REVISED RESPONSE TO REQUEST FOR ADDITIONAL INFORMATION

APR1400 Design Certification

Docket No. 52-046

RAI No.: 301-8280
SRP Section: 07.01 – Instrumentation and Controls
Application Section: 07.01
Date of RAI Issue: 11/10/2015

Figure 1. Probability Density Function (PDF) for Fq Modeling Errors

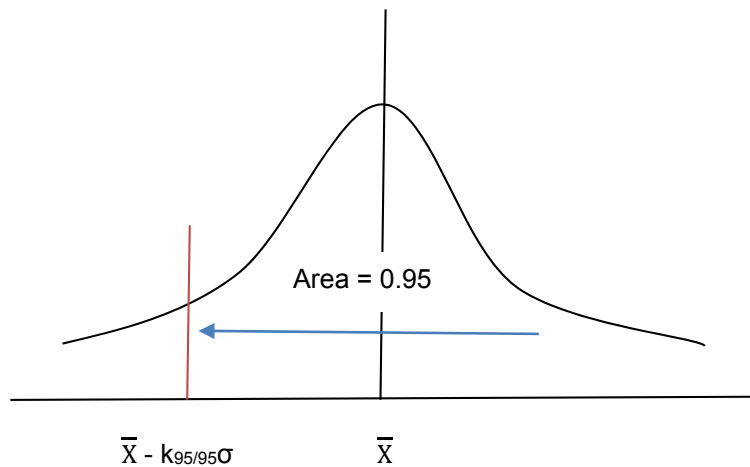
Section 2.1.3, "LPD LSSS statistical methods," of the CPC Setpoint Analysis Methodology Technical Report, states for Equations 2.3 and 2.5 state a normal distribution confidence coefficient of 1.645 for 95% confidence. It is not clear to the staff why these coefficients are consistent with the 95/95 tolerance limit discussion in Regulatory Guide 1.105, Rev. 3, which the staff interprets the limit to correspond to an error distribution approximately equal to two sigma value, 1.96, and not 1.645 as stated in the Technical Report APR1400-F-C-NR-14001. Provide the basis for using this factor with respect to Regulatory Guide 1.105, Revision 3.

The overall uncertainty factor analyses for the core protection calculator (CPC) local power density (LPD) are performed by comparing the 3-D peaking factor (Fq) that is calculated by the reactor core simulator and the peaking factor that is calculated by the off-line CPC, as described in technical report (TeR) APR1400-F-C-NR-14001, Rev. 1, "CPC Setpoint Analysis Methodology for APR1400"

The Fq modeling error (X_F^i) between the CPC synthesized Fq and the actual Fq is defined as follows:

Where ("SYN" Fq)ⁱ and ("ACTUAL" Fq)ⁱ are the CPC Fq and the reactor core simulator Fq for the i-th case. The Fq error is analyzed for each case at each time-in-life. Approximately 1200 cases are analyzed at each time-in-life (BOC, MOC, and EOC).

The value of 1.645 in the note of equation 2.5 is the 95/95 “one-sided tolerance limit factor” for infinite number of data points. In reality, the value of k is not 1.645 but rather depends on the sample size (N). In the description of the notes below equation 2.5, there is an editorial error. The description “(k= 1.645 for a 95/95 probability/confidence level and infinite” should be corrected as “... (k = 1.645 for a 95/95 probability/confidence level and infinite number of data points)”
